## Detailed Site Plan The Standard at College Park

**DSP-19068**

STAFF REPORT

SUBJECT: Detailed Site Plan DSP-19068  
The Standard at College Park

*Figure 1: South and North Elevations*

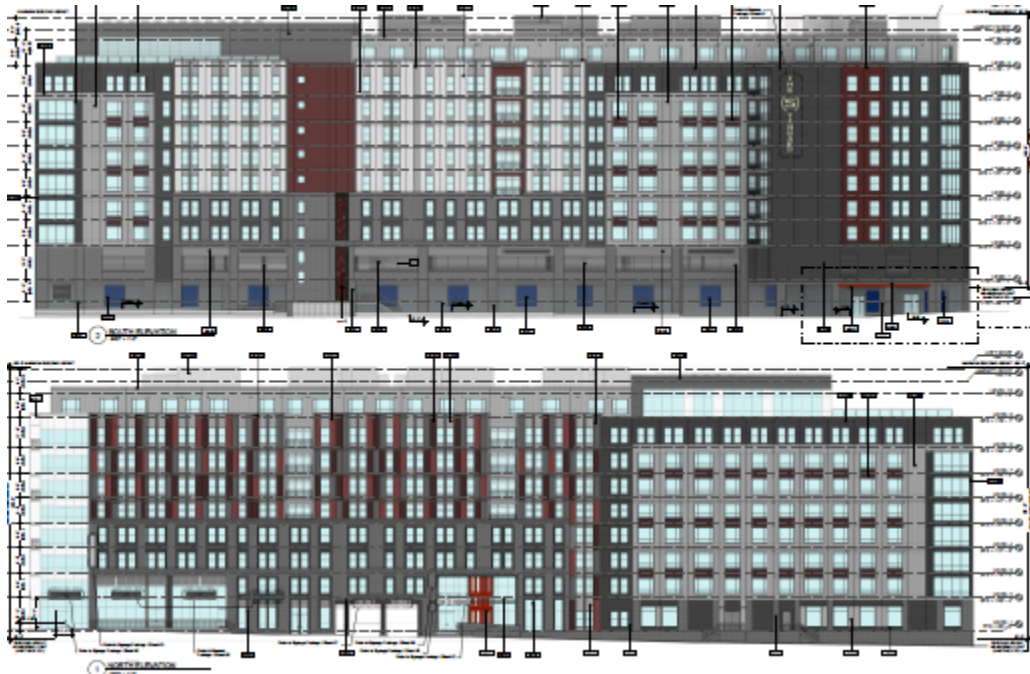
**Architecture**—The building will be composed of acrylic panels, and brick, in different shades of red, grey, and white. Glass, as well as metal, decorative panels complete the composition. Dark grey masonry elements are used to ground the building, while glass and a ribbon of cantilevered balconies act as a landmark feature above the first floor glass retail storefronts on the northeast corner of the building. Red metal and decorative panels draw interest to the residential entrances on Hartwick Road and Guilford Drive. The two parking levels will be set into the grade and will have no internal circulation. The Hartwick Road (northern) façade will have a centrally located parking access that is flanked by the retail space and the residential lobby. The applicant has addressed the two levels of parking on the Guilford Drive frontage (southern) by recessing the ground floor to create a public plaza and arcade. Decorative panels will provide added interest to this façade. Details of these decorative panels were not provided, and staff recommends a condition be added to require details and/or images be provided on the plans prior to certification. Brick columns break up the massing and metal louvers fill the second level openings. Red metal canopies highlight doors on the southeast corner of the building. The upper facades use a unique blend of materials and textures in a variety of ways to develop a distinct pattern that separates the larger building into smaller parts. The top stories step back and use light grey materials to cap the building. The eastern and western elevations continue a similar pattern of materials and colors.

The materials and colors selected to face the proposed building are compatible with those utilized in similar scale developments recently constructed within the development district. The materials proposed include a mix of colored acrylic panels, glass, and masonry elements in tones of grey, white, and red. Trim, coping, and other detail elements are provided in darker complimentary tones and materials, as well.

- m. Provide at least one car sharing parking space.
    - n. Provide a continuous expression line above the second floor along the Hartwick Road façade and extend the balconies on this façade to meet the expression line.

Figure 3: Signage

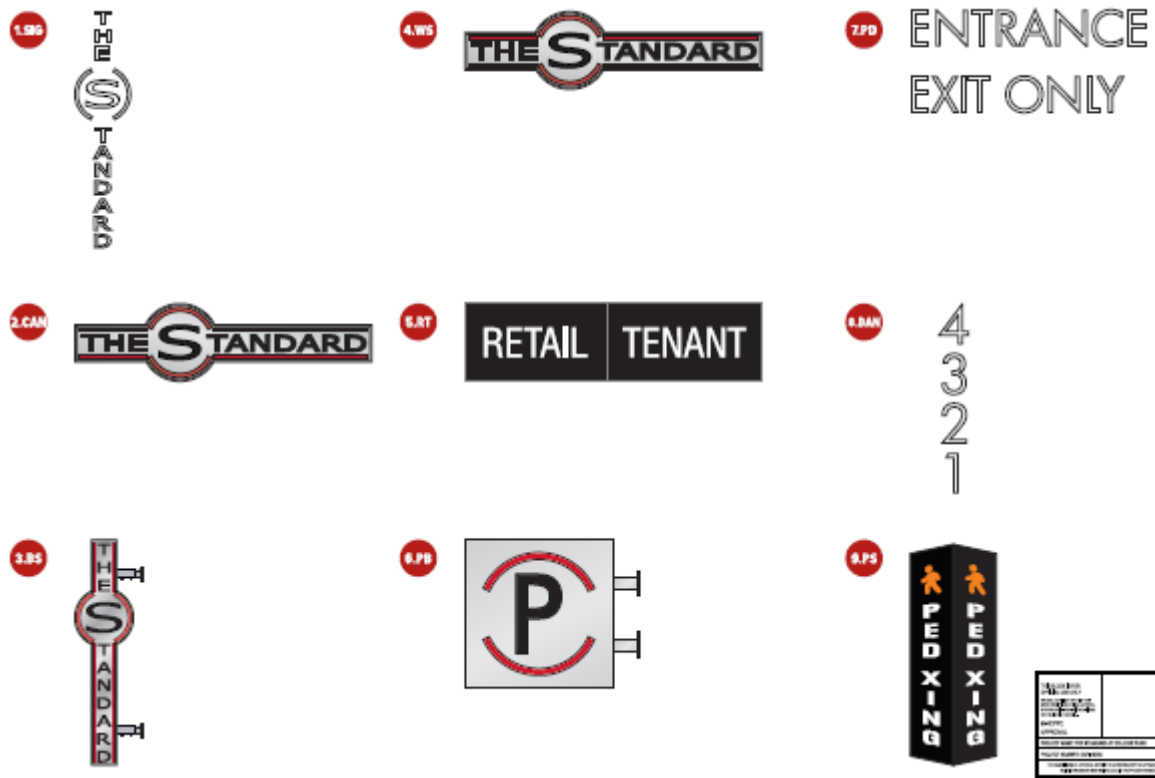
The submitted sign plan for the project includes the square footage and all details necessary to fully evaluate conformance with the sign requirements of the D-D-O Zone. A proposed amendment has been requested for the blade sign. Staff is recommending approval; the applicant provided scaled details of all the signs and elevation drawings showing their location on the façades in accordance with the applicable sign requirements.

- (3) Where feasible, show trees planted along the sidewalk edge on applicant's property to align with street trees for more effect.
  - s. Revise the sign plan to clarify sign construction details to ensure that panelized back lighting and box lighting fixtures are not provided.

GUILFORD STREET EXTERIOR ELEVATION

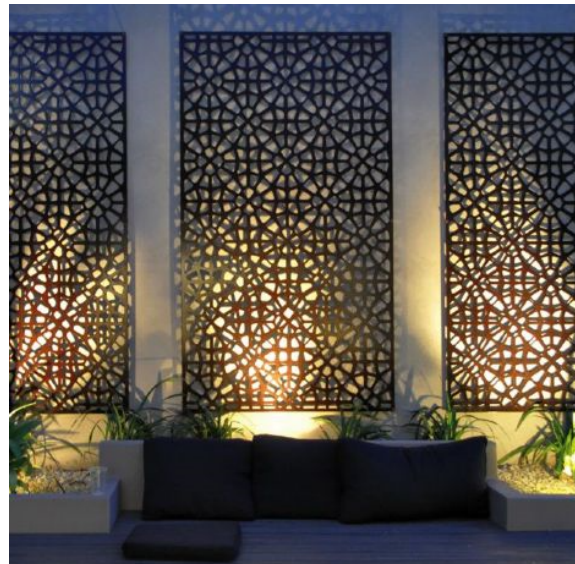
METAL PANELS ATTACHED TO FACADE

- p. Provide a detail of the proposed decorative panels to screen the parking garage along Guilford Drive.
  - q. Provide the location and type of trees and pedestrian lighting for the streetscapes along Hartwick Road, Guilford Drive and the new access road. These details should be consistent with the streetscapes provided to the east and west of the subject site.
